STAFF REPORT

To: University Heights Zoning

Prepared by: MPOJC Staff

Requested Action: Rezone 901, a portion of 905 and 909
Melrose Avenue from Single-Family
Residential (R-1) to Planned Unit
Development (PUD)

Figure 1: Concept Plan with building reorientation

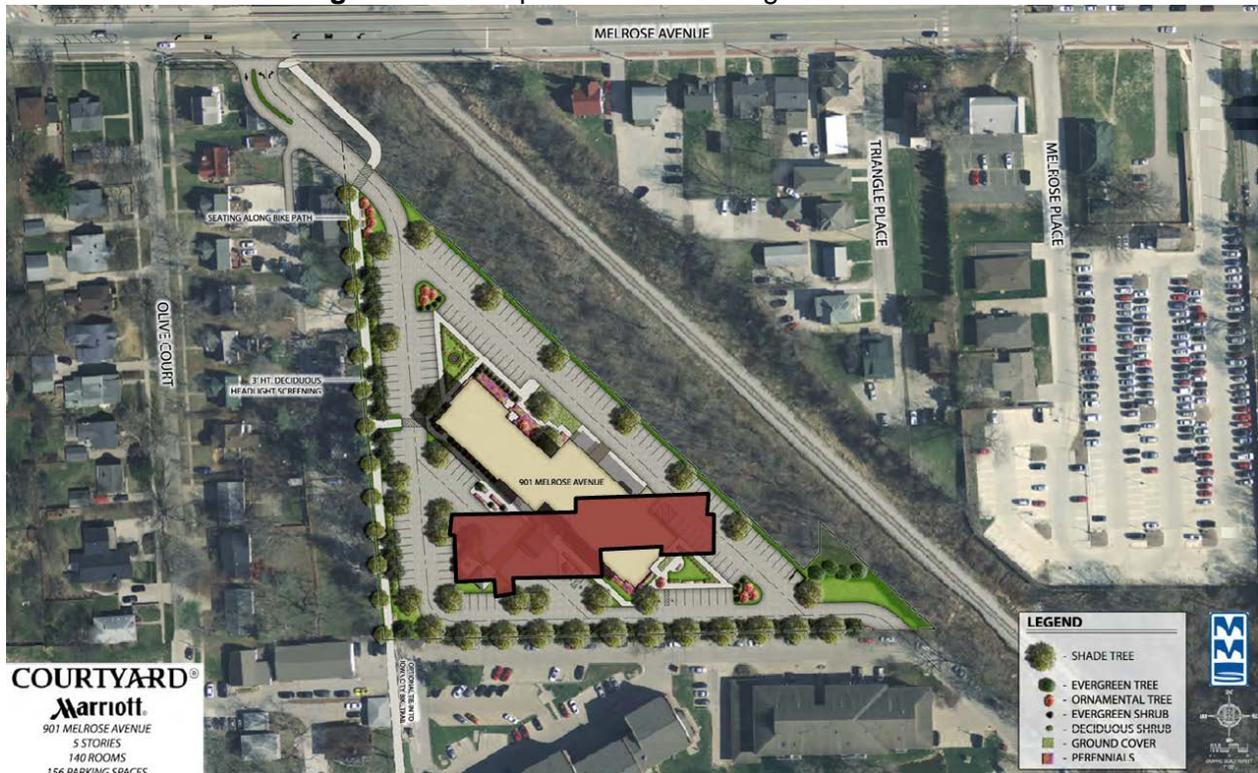
The proposed building is situated to the south side of the property, oriented parallel with the east property line, with the hotel entrance facing single-family residential properties to the west. This orientation may create unnecessary negative externalities, such as noise and light, for the single-family residences on Olive Court. The City and the applicant should discuss reorienting the building so that the back of the hotel is facing the medium-density apartments to the south and the front is facing Melrose Avenue. The proposed use of the property is similar to the medium-density apartments to the south in that it has a comparable physical characteristic (multiple-story building, large parking lot, etc.). Reorienting the hotel in this way would improve the presentation of the entrance and may reduce some of the negative externalities associated with a hotel entrance experienced by the single-family residences to the west. For reference, Staff reoriented the building to scale on the concept plan as shown in **Figure 1**. With this configuration, a continuous access along the eastern property line would not be available and the site layout (landscaping, parking stalls, etc.) would need to be reconfigured.

9. The City may want to ask the applicant to investigate the possibility of reorienting the building so that the back of the hotel is facing the medium-density apartments to the south and the front is facing Melrose Avenue.

Figure 2: Hotel Concept Plan

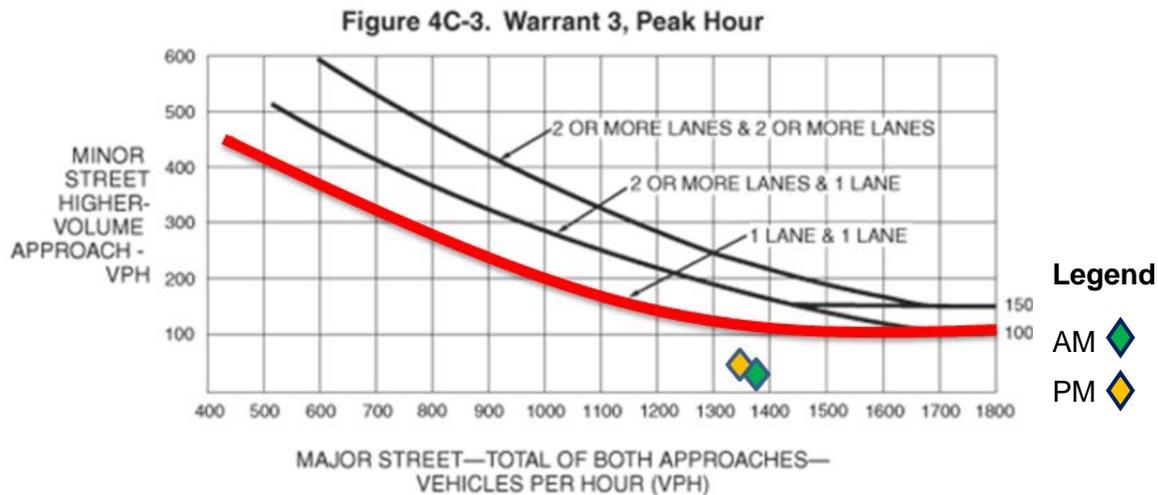
The turn lane on Melrose Avenue as proposed in the concept plan (**Figure 2**) only shows a left-turn lane for the proposed development and appears to have removed the existing left-turn lane for Evashevski Drive which is not suitable. As the Evashevski Drive and Melrose Avenue intersection is in Iowa City, the City of University Heights does not have authority to alter the center left-turn lane and the applicant has not submitted documentation from Iowa City indicating authorization for this configuration. The left-turn lane for the proposed development should be developed as a 'shared' left-turn as it is currently striped. The concept also appears

to include a westbound left-turn lane at Olive Court and dedicated bike lanes on Melrose as recommended in the Melrose Avenue Streetscape Improvement Plan which should be viewed favorably. The applicant is proposing a full-service access where left and right turning movements into and out-of the development are permitted. The final design and specifications for the access will need to be reviewed and approved by the City Engineer.

12. The left-turn lane on Melrose Avenue as proposed in the concept plan only shows a left-turn lane for the proposed development and appears to have removed the existing left-turn lane for Evashevski Drive which is not acceptable. The left-turn lane should be developed as a 'shared' left-turn as it is currently striped.
